April 2016 Contingency Use Requests

CALEB DUSTIN HUNKING MIDDLE SCHOOL SCHOOL BUILDING COMMITTEE MEETING

MEMORANDUM

To: Kathleen Smith, City of Haverhill
 From: William G. Cunniff – NV5
 Date: April 26, 2016
 Re: GMP & Construction Contingency Approval: Caleb Dustin Hunking School
 Cc: James F. Scully; Jeffery Luxenberg; Adam Sniegocki

Request for Information RFI315

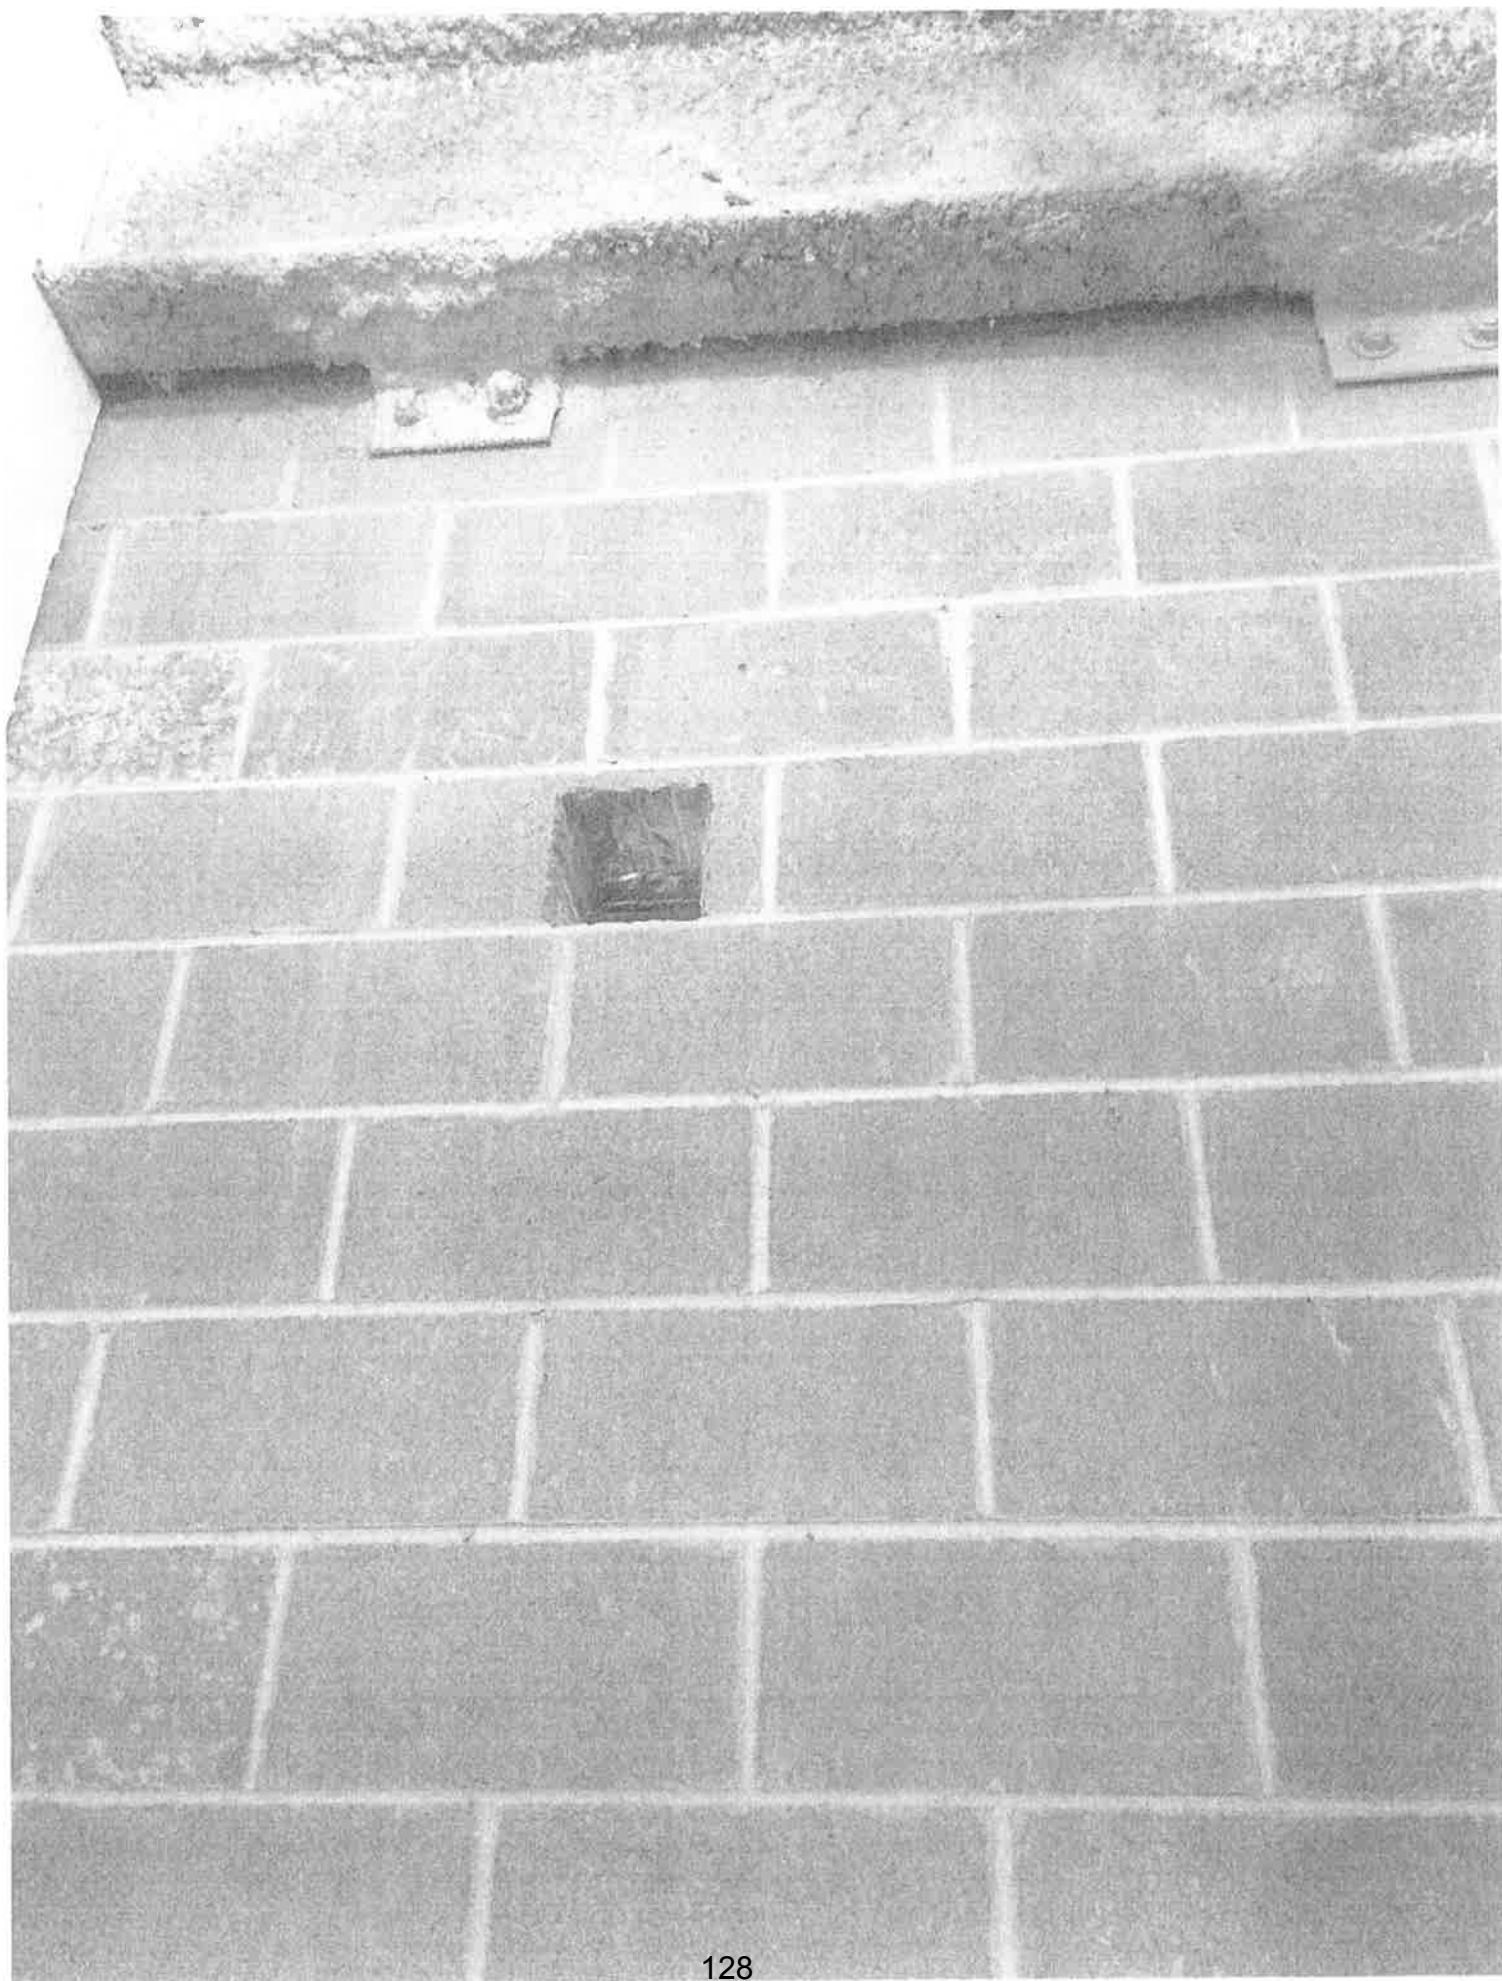
Question Please see the following from the elevator contractor: "The vent for the elevator machine room is currently much lower than the highest point of the machine room. In our past experience, the elevator inspector is looking for the machine room vent to be as close to the top of the machine room ceiling as possible (so that smoke/etc will vent out of the machine room properly). If the machine room vent is not as close as possible to the ceiling, he may not pass the elevator during inspection. We recommend adjusting this now to avoid any potential issues during the elevator inspection. One possible method to achieve this is to install a hard ceiling to bring the 'ceiling' level down to the vent height." Please see the attached response to RFI 315 and a picture from room C134B. RFI 315 added a hard ceiling to the elevator machine room (room A212B). Please confirm it is acceptable to add a hard ceiling in room C134B as the same situation occurs.		Date Required: March 28, 2016

Suggestion			
Answer This is acceptable. KKL 03/21/16		Date Answered:	
Cc: Company Name		Contact Name
